HISTORIC DISTRICT COMMISSION

CONWAY HISTORIC DISTRICT COMMISSION MEETING

PRAIRIE STREET CAMPUS MASTER PLAN CERTIFICATE OF APPROPRIATENESS REVIEW

PHOENIX RECOVERY NEW OFFICE BUILDING CERTIFICATE OF APPROPRIATENESS REVIEW

PRAIRIE STREET CAMPUS
MASTER PLAN

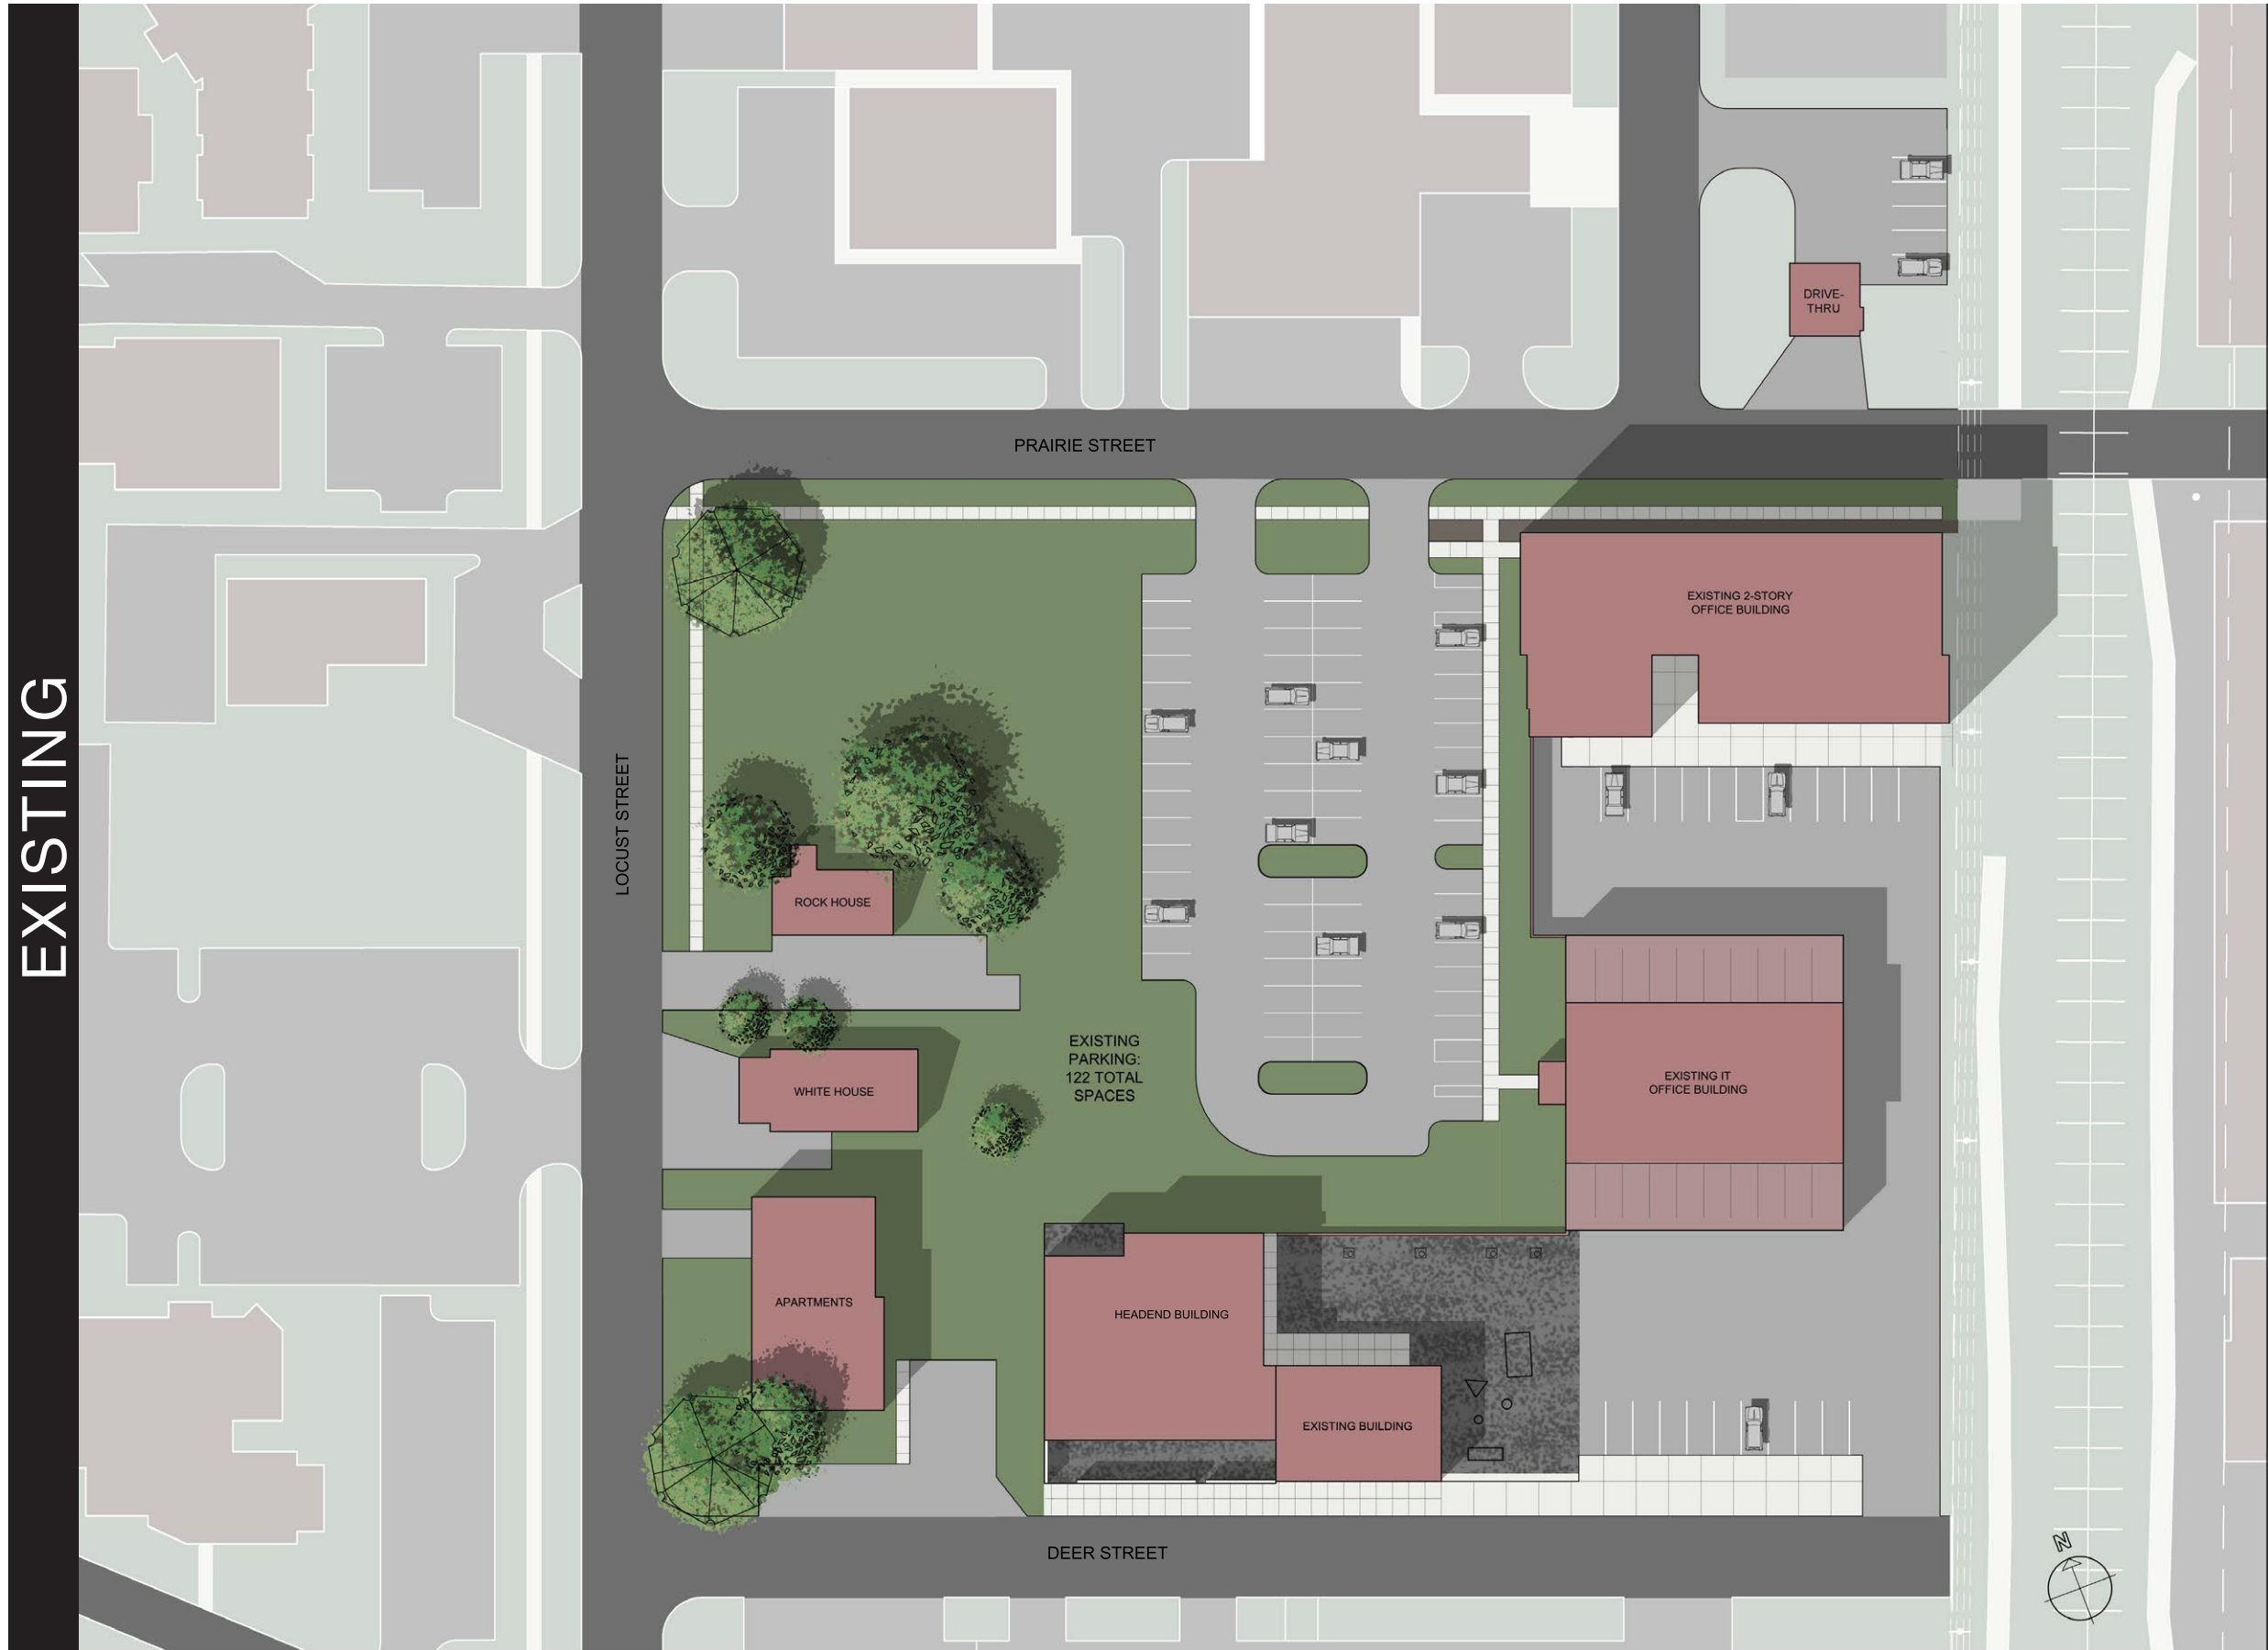
Vehicular Access Points: Curb cuts in the Urban Zone shall be no greater than 20 feet in width. When interrupted by a vehicular access point, the continuity of the sidewalk surface material and grade shall be maintained and the material and grade of the driveway interrupted. The curb cut shown on Locust is 40 feet wide. This should be reduced. The use of materials to visually continue the sidewalk across curb cuts is encouraged.

Driveway / Parking: Corner parking lots are not permitted. When a parking lot abuts a public sidewalk, a visual buffer shall be provided through the use of a wall or fencing along the sidewalk edge. Materials should be compatible with those of nearby buildings and utilize visually interesting elements, such as masonry patterns, articulation, and vegetation. In situations where walls are not appropriate, a landscape buffer may be utilized. However,

landscaping shall be dense and unbroken in order to completely meet the spirit and intent of this section. Planting strips and planter boxes may be incorporated to assist in fulfilling this requirement. Several low brick walls are proposed to screen the parking areas.

Sidewalks: The OCDOD Ordinance requires sidewalks to be constructed along all street frontages and located within the public right-of-way. As a commercial development in the Urban District, these sidewalks should be wide and pedestrian friendly with tree wells. Sidewalks shall extend from the structure's facade outward to the existing curb line of the street. Upon build-out in phase 4, appropriate sidewalks surround the property. Tree wells should be continued down the length of Prairie Street. Any street lighting should use the adopted downtown light standard design.

Tree preservation: There are at least 6 large oak trees that will be affected by construction. There are two large oak trees that appear to be preserved by incorporating them into the plazas at the corners of Prairie and Locust and Deer and Locust. Utmost care and tree preservation practices would be required during construction in order to keep these trees alive.

Lighting: No light fixtures are shown at this time. However, any building or parking lot lighting should be inward, downward, and shrouded to stay within the bounds of the property.

monument sign no larger than 16 square feet in area and 4 feet tall is allowed. A larger freestanding monument sign requires the approval of the HDC. Phase 1 mentions the placement of monument signs at each new entrance. The HDC has approved several commercial monument signs 6 feet tall and 36 square feet in area.

1. The submitted phased plans shall serve as guideline documents for future development of the Conway Corporation campus.
2. Tree preservation?
3. Signage?
4. Additional tree wells along Prairie Street - possibly use adopted street detail for recent Oak Street developments?

PROPOSED BUILDING ELEVATIONS

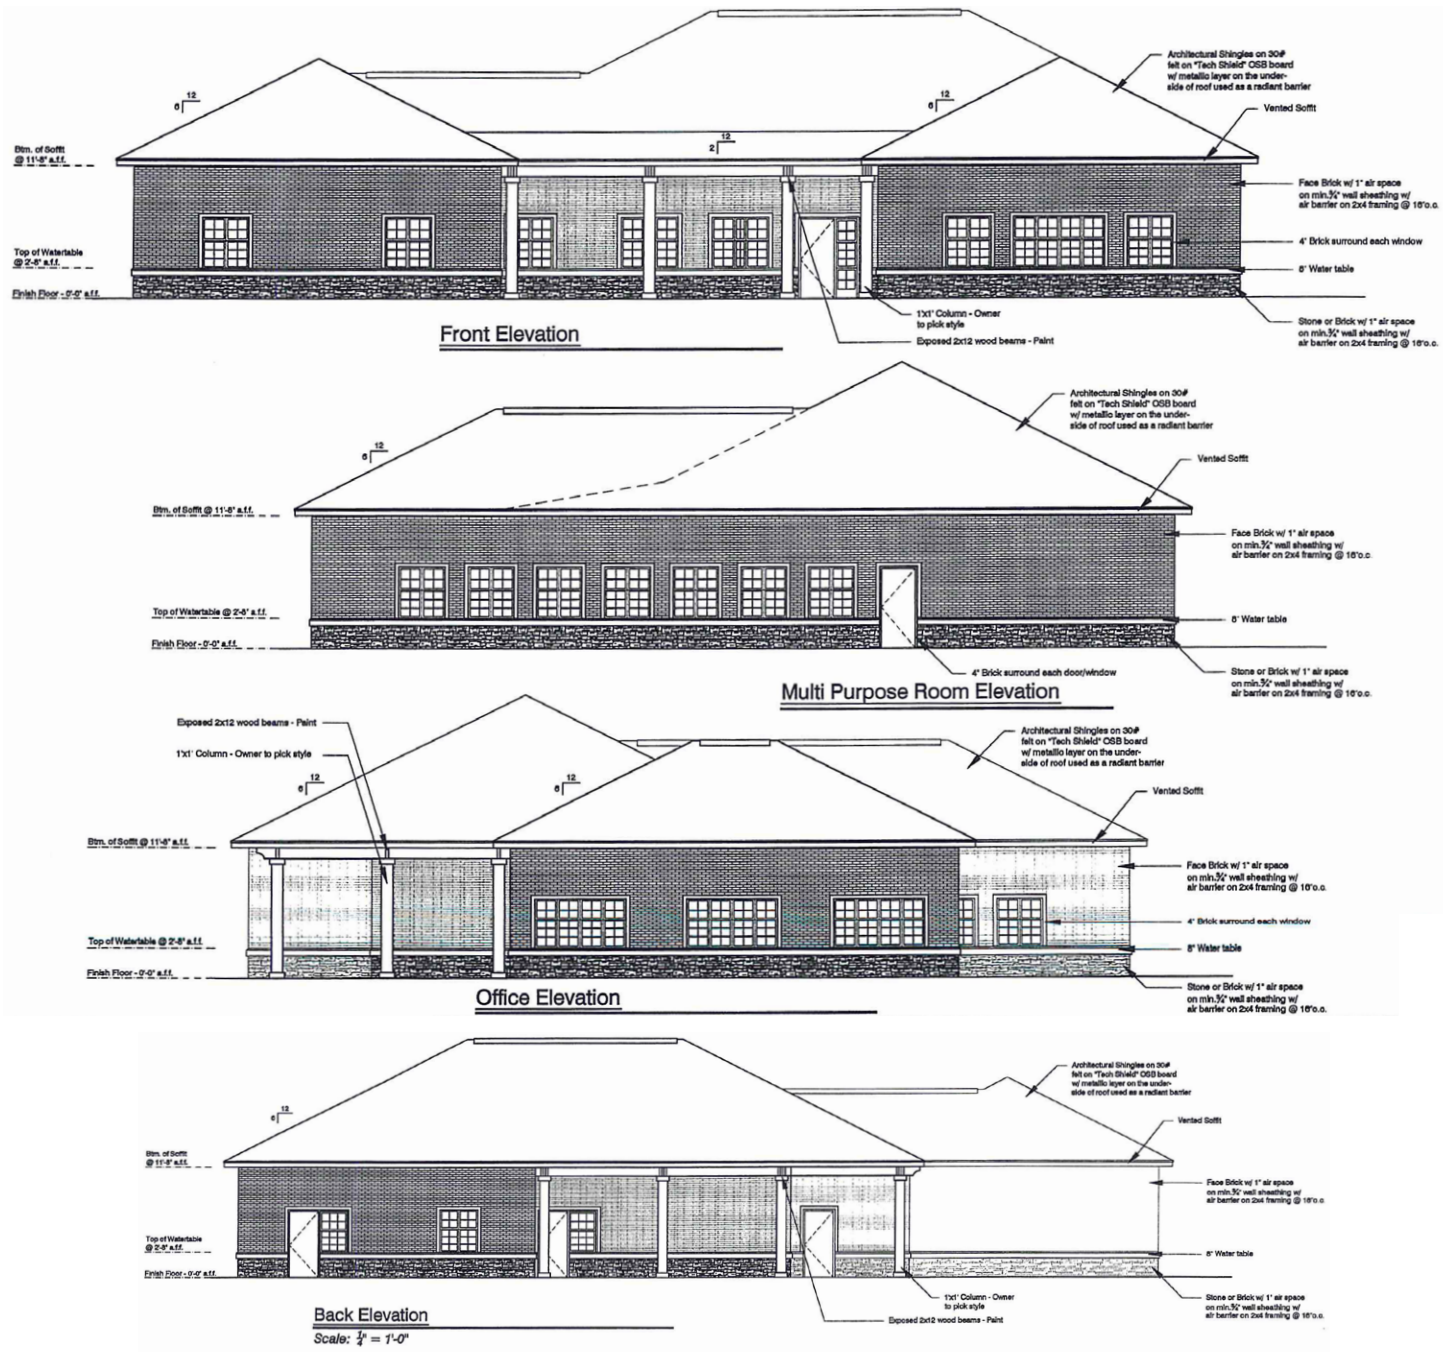
Width: New construction proportions shall respect the average widths of the majority of neighboring buildings in the area. The office is wider than area residences, however, the front facade's plane is broken into sections, thereby decreasing the overall mass.

Complexity of form: The level of detailing and breaks in wall planes of a structure. The office has breaks in the wall planes, a base, "middle", and cornice. Columns and arbor like beams add to level of complexity and is appropriate.

Facade, wall area, rhythm: Facades shall be compatible with surrounding historic structures in proportion of wall to opening area. Window and door openings should correspond to the rhythm and proportion on existing structures. Generally doors and windows should be proportioned in a range of 25-40% of the total surface area. Except for the rear elevation, which is largely hidden, the facades have a large percentage of windows and doors.

Entries, porches and porticos: Porches should have a minimum depth of 6'-0". Porches are around 7'-6" deep.

Architectural details, siding and bricks: Eaves, brackets, dentils, cornices, molding, columns, trim, etc. A brick veneer wall with a water table band and stone or brick base is proposed. Windows and doors are trimmed with brick surrounds. Columns and arbor like wooden beams are proposed at porches.

Roof: An architectural ; asphalt shingle roof is proposed.

1. The structure shall be constructed as submitted.
2. Reduced front and rear setbacks shall be allowed. These setbacks shall be approximately 14-15 feet from the property line.
3. Parking and driveways shall be reviewed as part of staff development review. Ingress/egress, landscaping, lighting, etc. shall meet development review standards.
4. Any site lighting shall be inward, downward, and shrouded.
5. Sidewalks or an in-lieu fee are required for the Jersey Street frontage.
6. HVAC units should be visually located away from streets or screened by landscaping.
